RE: Recommendation to approve NB Kenney Change Order 005

NB Kenney is submitting original copies of Change Order 005 for the Brookline High School Deferred Maintenance Project for acceptance by the Town of Brookline (ToB). Hill and WRA have previously reviewed, negotiated where applicable, and agree that all items listed in this Change Order are fair, reasonable for the described scope of work, and are compensable adjustments to the Lump Sum Contract. This change order is an additional cost funded from Owner' Hard Cost Contingency total **\$40,310.00**.

## Change Order

**PROJECT: (name and address)**Brookline High School  
115 Greenough Street  
Brookline, MA 02445**OWNER: (name and address)**Town of Brookline - Represented by  
The Brookline Building Commission  
333 Washington Street  
Brookline, MA**CONTRACT INFORMATION:**Contract For: Deferred Maintenance  
Expansion Project**ARCHITECT: (name and address)**William Rawn Associates, Architects, Inc.  
10 Post Office Square  
Boston, MA 02109**CHANGE ORDER INFORMATION:**Change Order #: 5  
Date: November 29, 2021**CONTRACTOR: (name and address)**N.B. Kenney Company, Inc.  
68 Barnum Road  
Devens, MA 01434

# M2-01-F

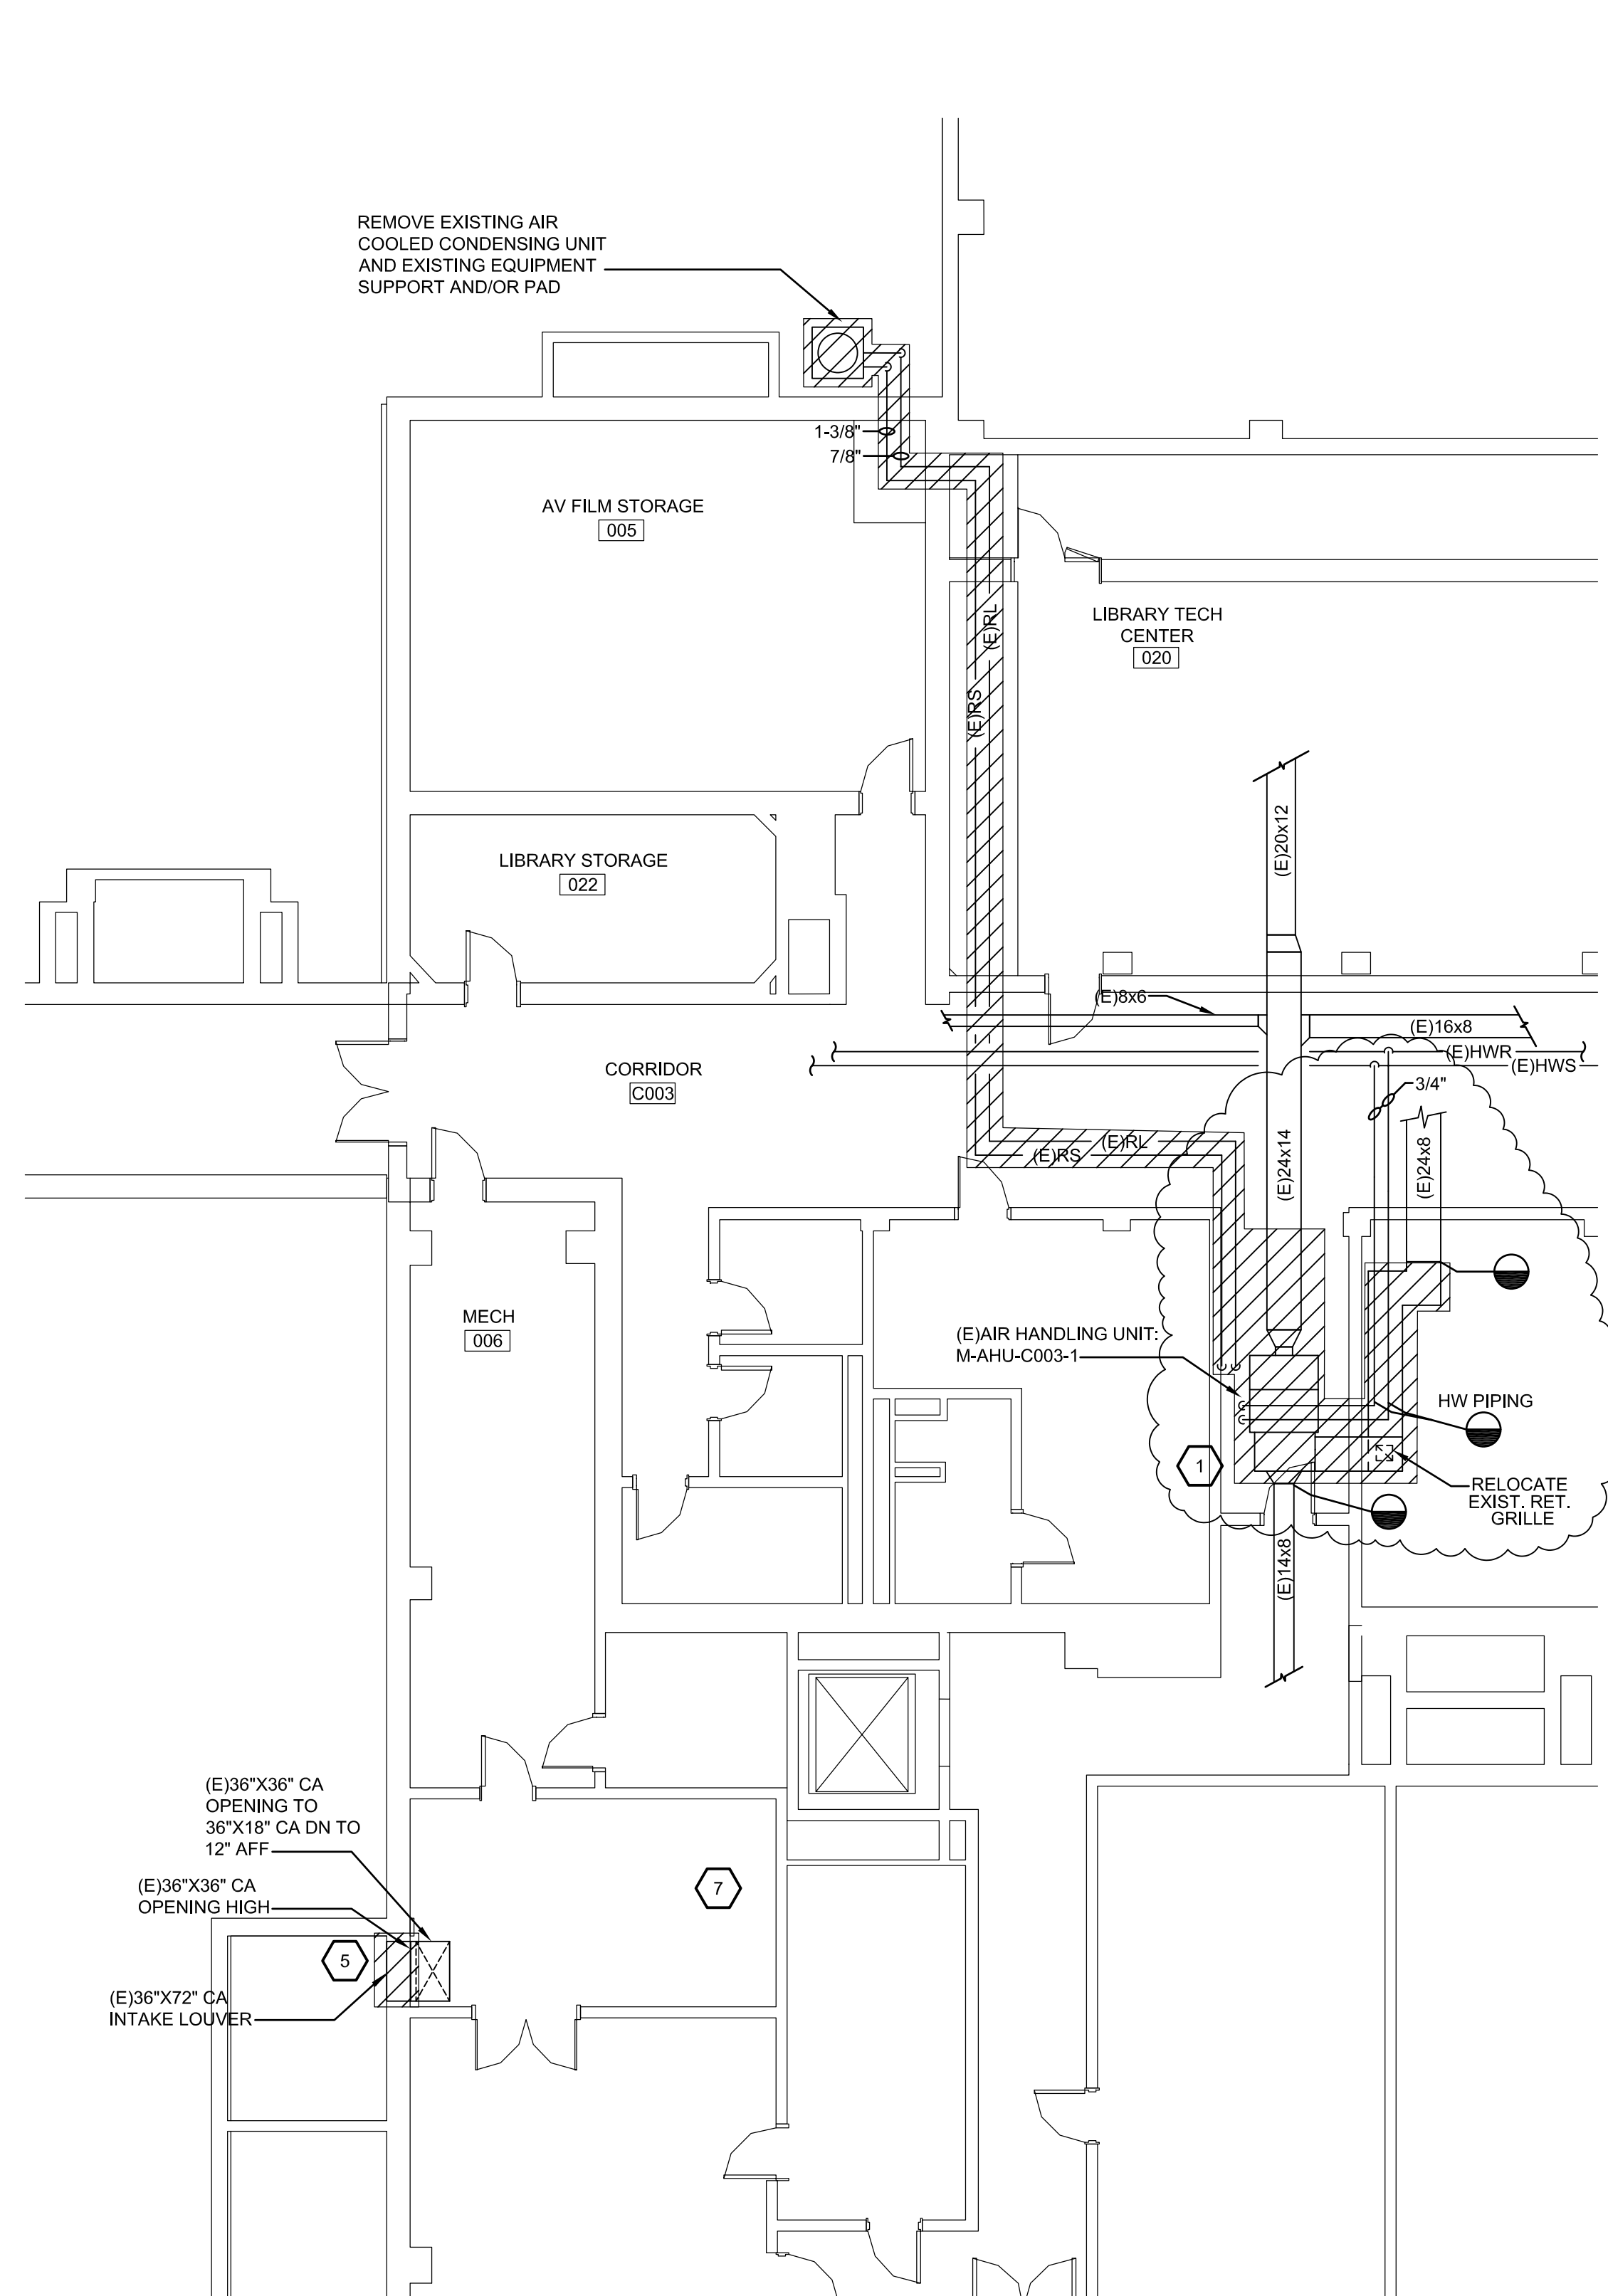
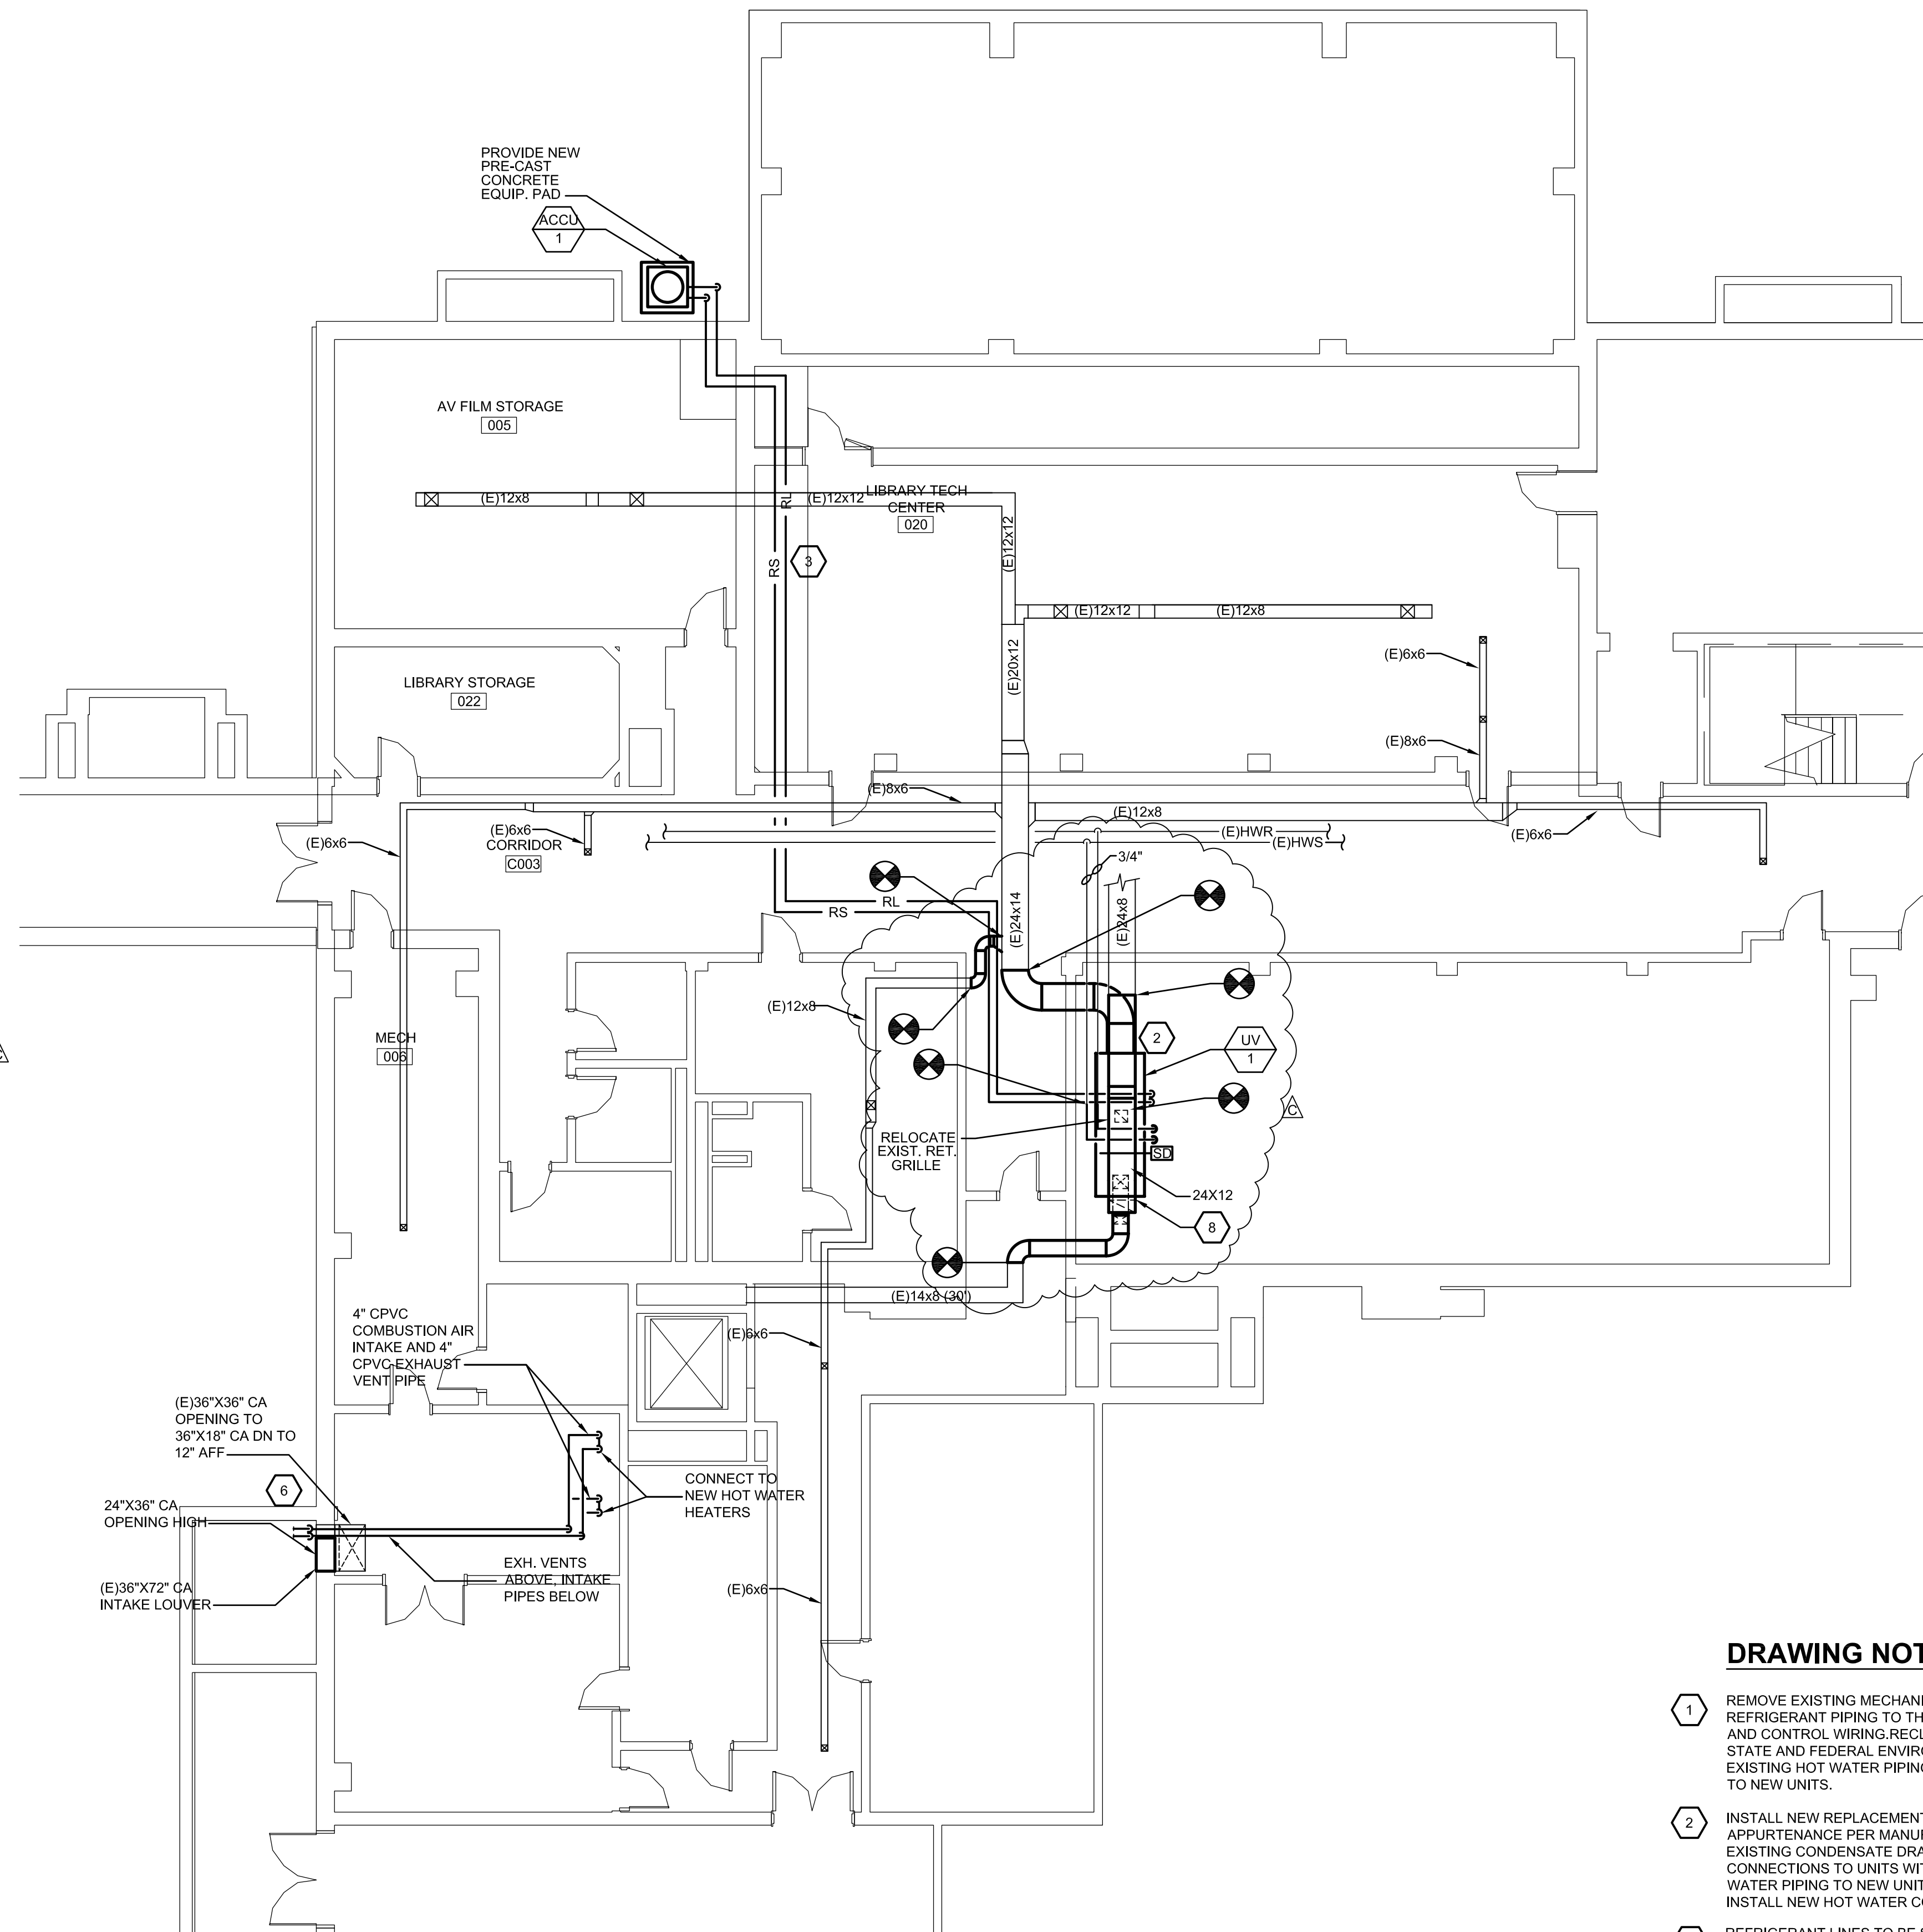
We are hereby submitting the following questions for your response. These issues have potential time and cost impacts. Reference is made to drawing M2-01-F that shows a new UV-1 in the basement level of the High School Main Building in Corridor C003 and drawing M5-01-F Mechanical Schedule. The schedule calls out for the new unit to be a Trane CSAA006 Performance Climate Changer; this unit was submitted, approved, and installed. As you can see from the attached four (4) photo's the new unit is considerably larger than the old unit being replaced. Currently, the bottom of the unit provides head clearance of 6'-4", in addition the access doors are somewhat restricted in their opening. The airflow configuration for this unit is per the attached sketch, the outside air connects to the back end of the unit and the return air connects to the bottom of the unit. When the return duct is connected there will be approximately 5' of head clearance which we believe presents a safety issue as anyone over 5 feet tall could hit their head causing bodily harm. The outside air and return air connect to the unit's mixing box, there is a possibility that the parallel blade damper could be removed and relocated to the top of the mixing box leaving a head clearance of 6'4" and while not ideal is certainly better than 5 feet. Please review and advise on how we are to proceed.

- Relocate UV-1 from the corridor into the adjacent room as shown.
- Remove the existing supply air smoke detector and reinstall in the new supply duct.
- Provide a new smoke detector in the return duct.

See RFS response above. Prior to any re-installation, NB Kenney is to verify the dimensions of the room to the west of the current UV-1 location. The design team will provide direction once the potential head height and access clearances are known.
